TOWN OF NEWBURGH PLANNING BOARD TECHNICAL REVIEW COMMENTS

PROJECT: FARRELL INDUSTRIAL PARK

PROJECT NO.: 20-16

RE: JMC Project 18156 Farrell Industrial Park Route 300 Town of Newburgh, NY

Drawn: TC Approved: DL/JS Scale: 1" = 50' 12/03/2020 18156-UTIL UTIL UTIL.scr

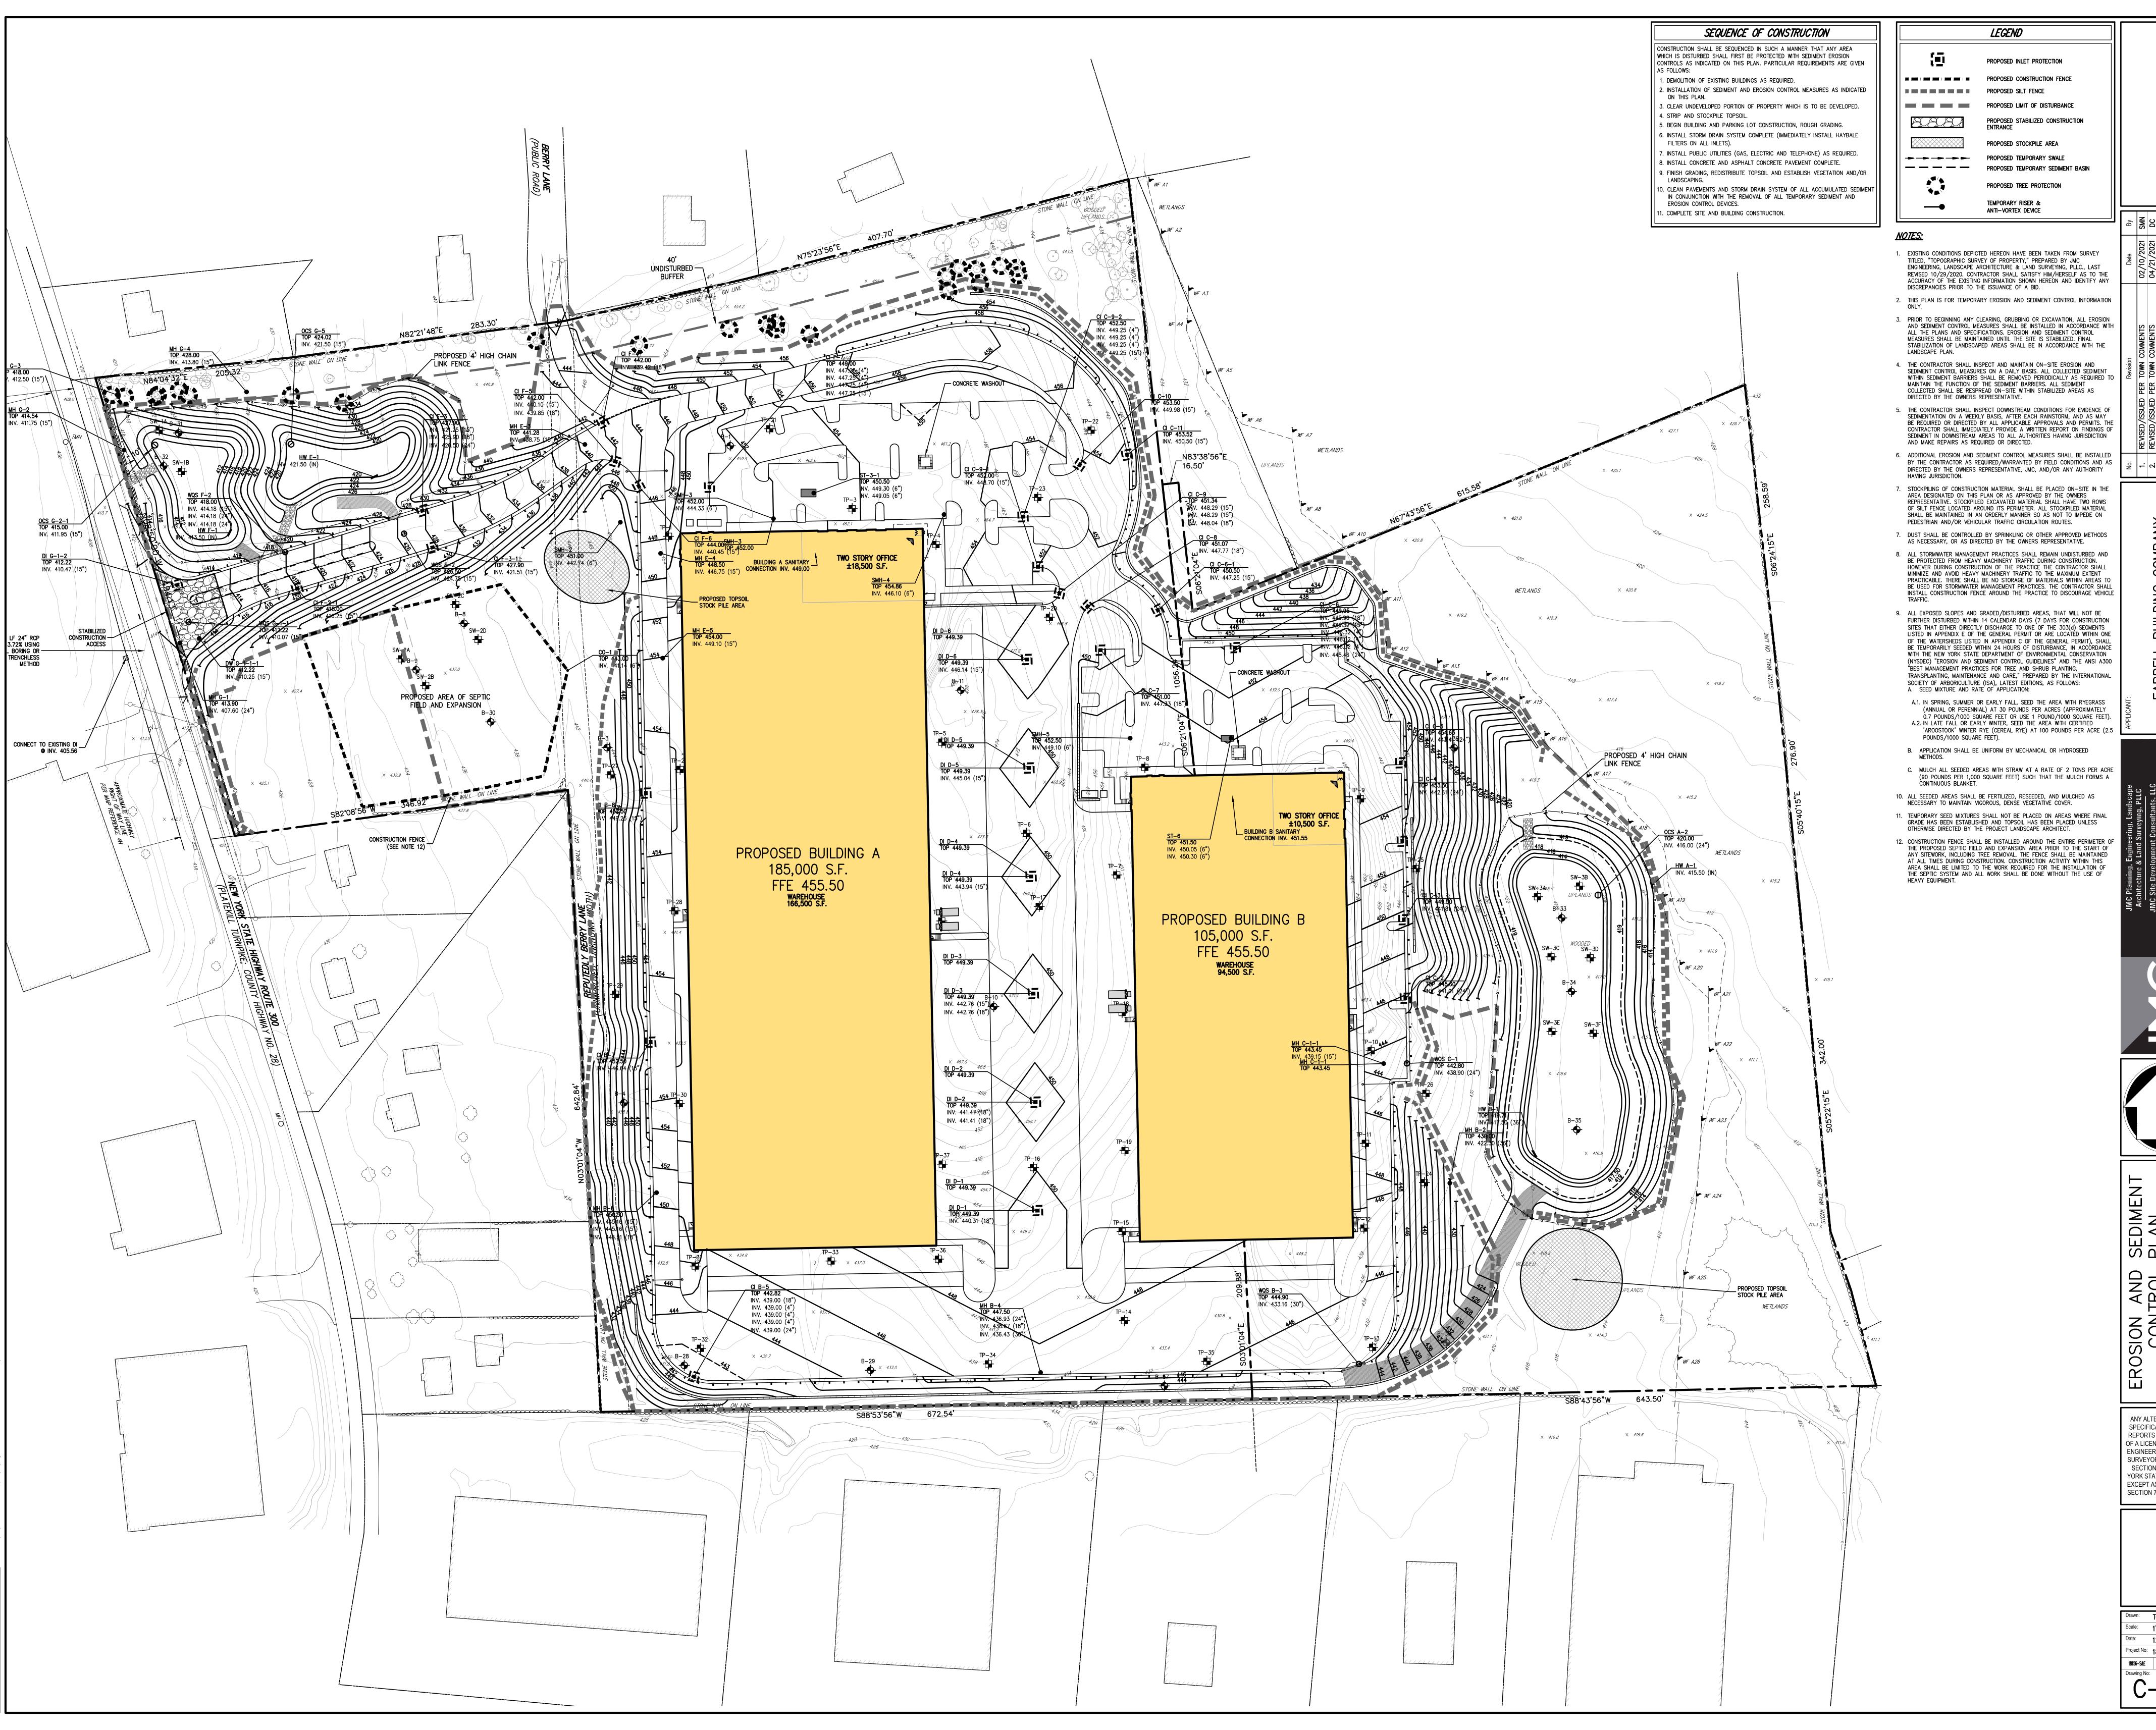
The fire and domestic water lines must show valve in such that termination of the fire line terminates the 4-inch domestic water line. The 4-inch valve depicted needs to be relocated to the 6-inch line prior to the tee for the potable water.

Detail 34 on Sheet C-903 identifies thrust blocks. Restrained joint pipe is required in the Town of Newburgh. A restrained joint pipe chart should be added to the plans.

The utility plan sheet C-300 has notes identifying items not considered in this project. I.e.; Note #27.

The fire and domestic services have been revised as noted above, as shown on the attached JMC Drawing C-300 "Utilities Plan".

As requested, Detail 34 has been removed from drawing C-903 and a restrained joint pipe chart has been added to drawing C-300.

All nonrelevant notes have been removed from drawing C-300.

Scale: 1" = 50' Project No: 18156 18156-S&E SE SE.scr

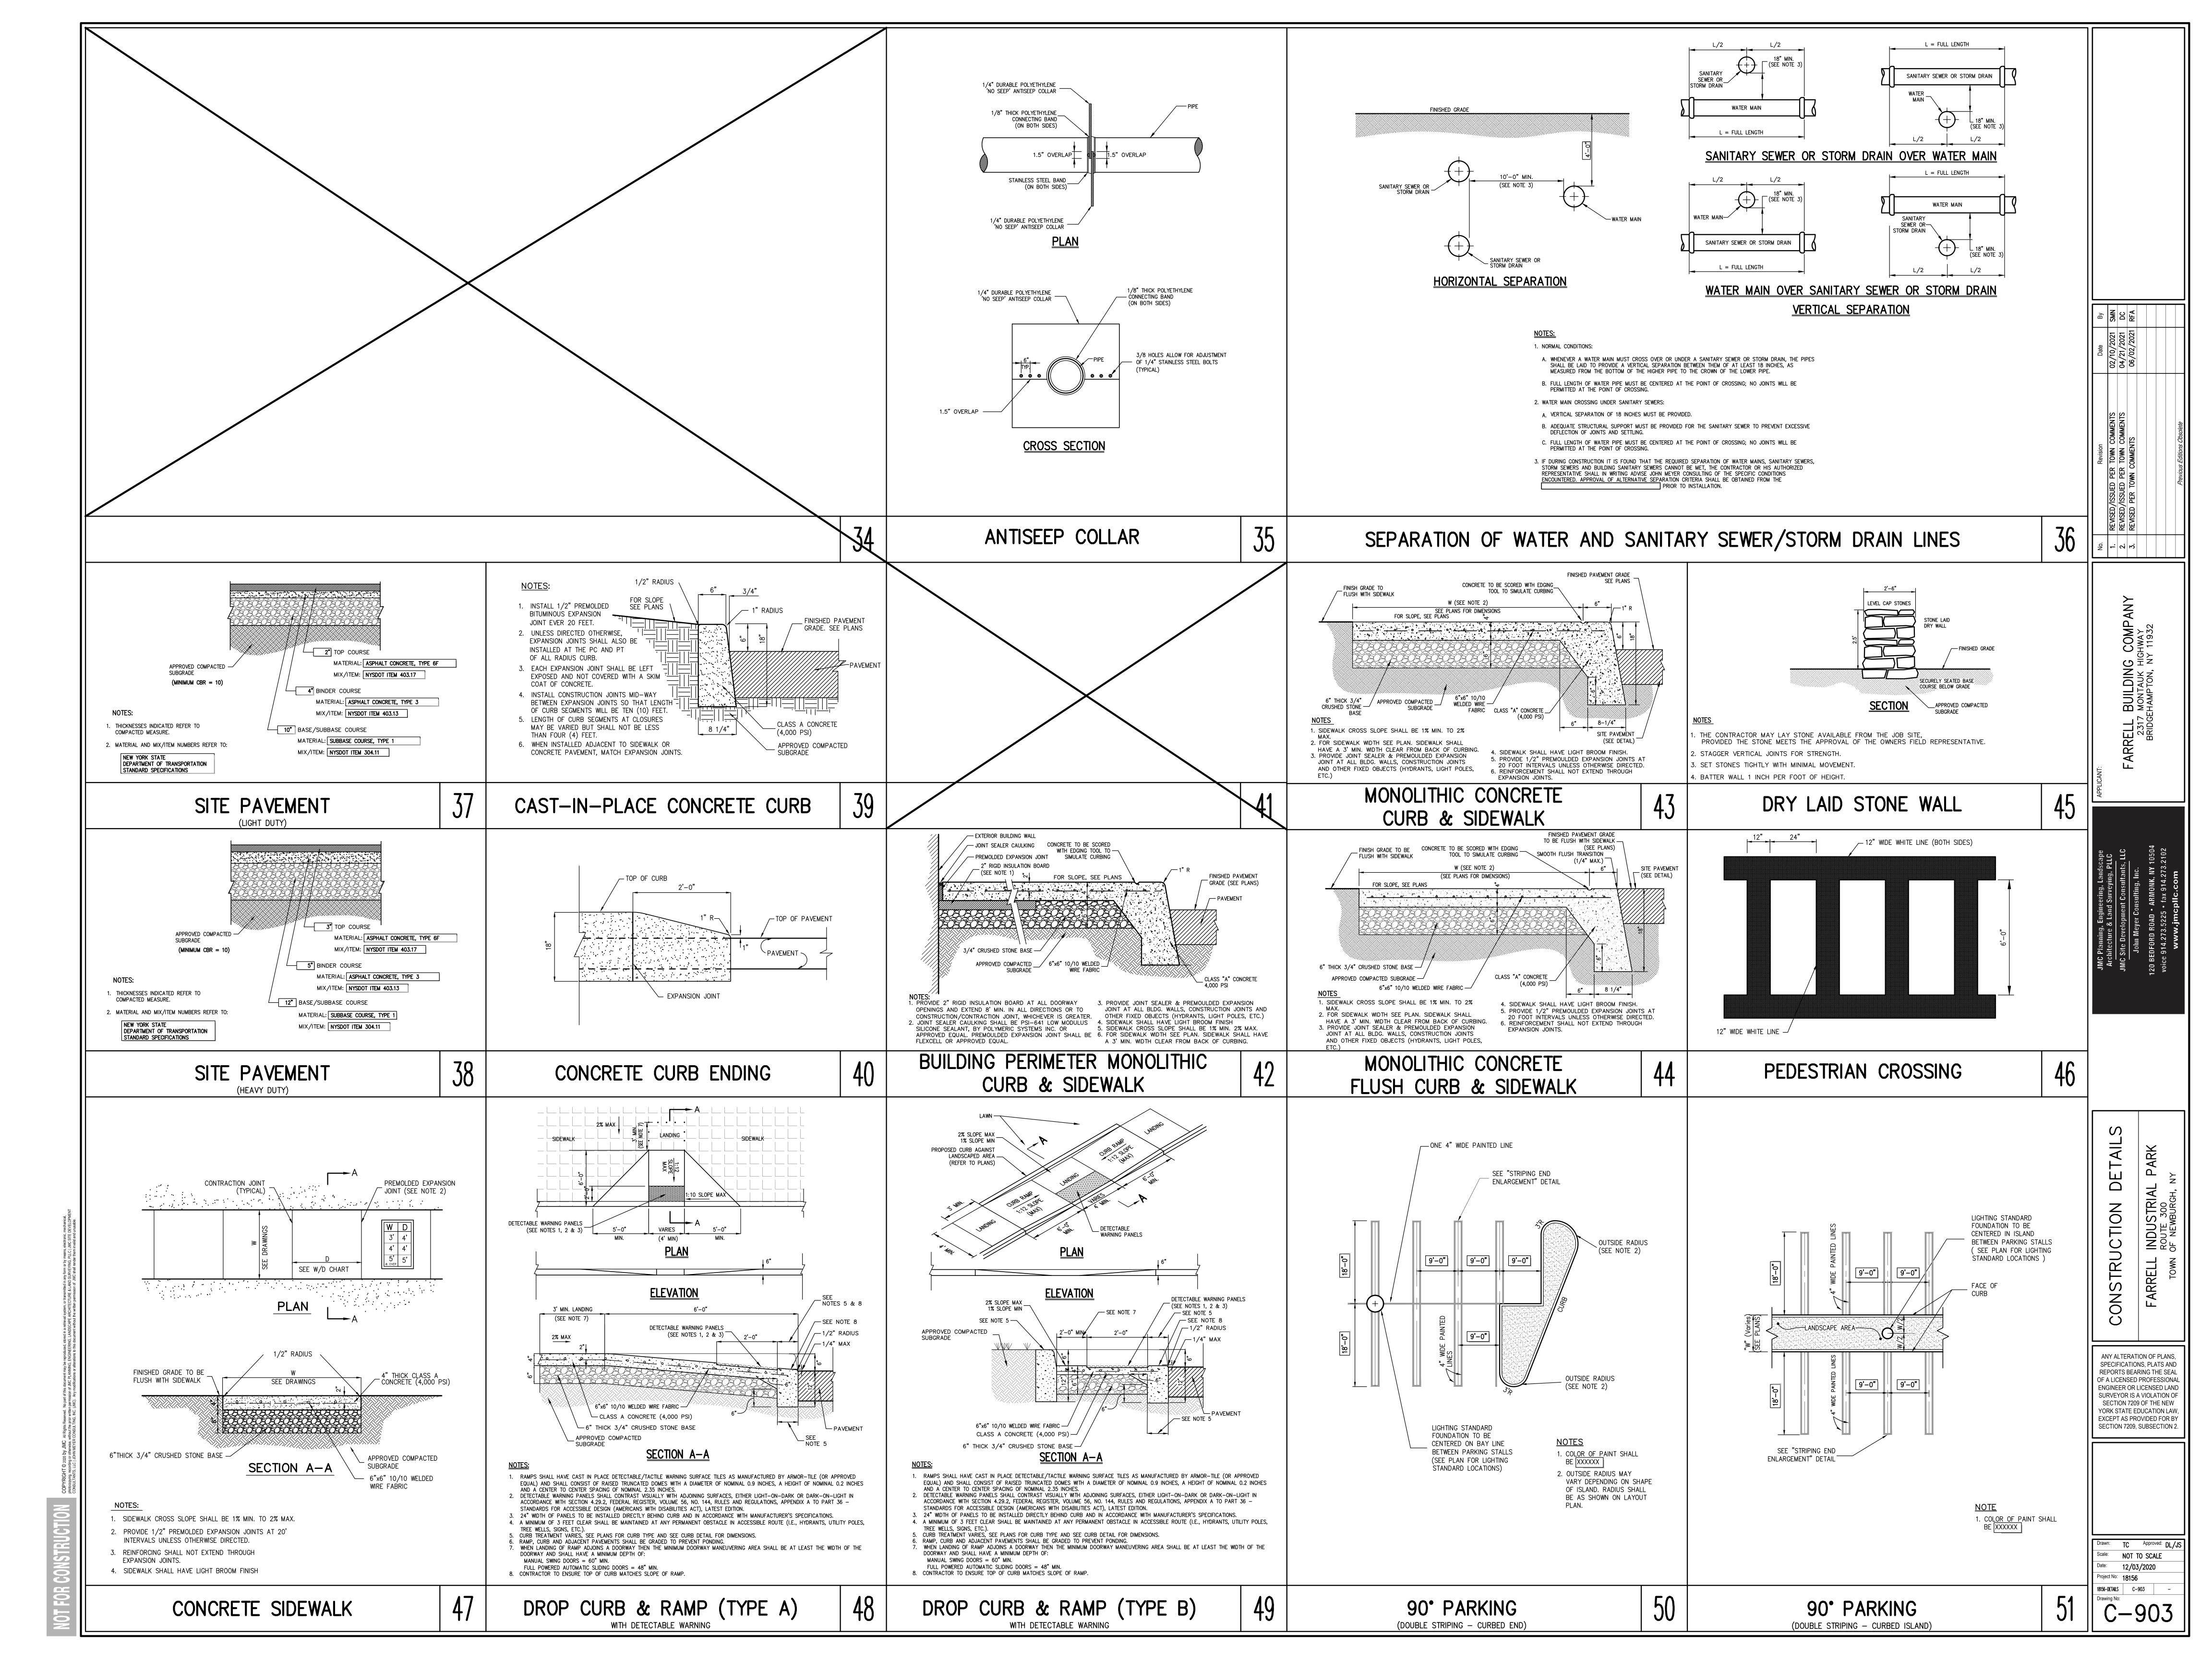
- **6.** The project should identify in the SWPPP and on the Soil Erosion and Sediment Control plans that it will be requesting a 5-acre waiver. The amount of area to be disturbed at any one time should be identified on the Construction and Erosion and Sediment Control Phasing Plan.
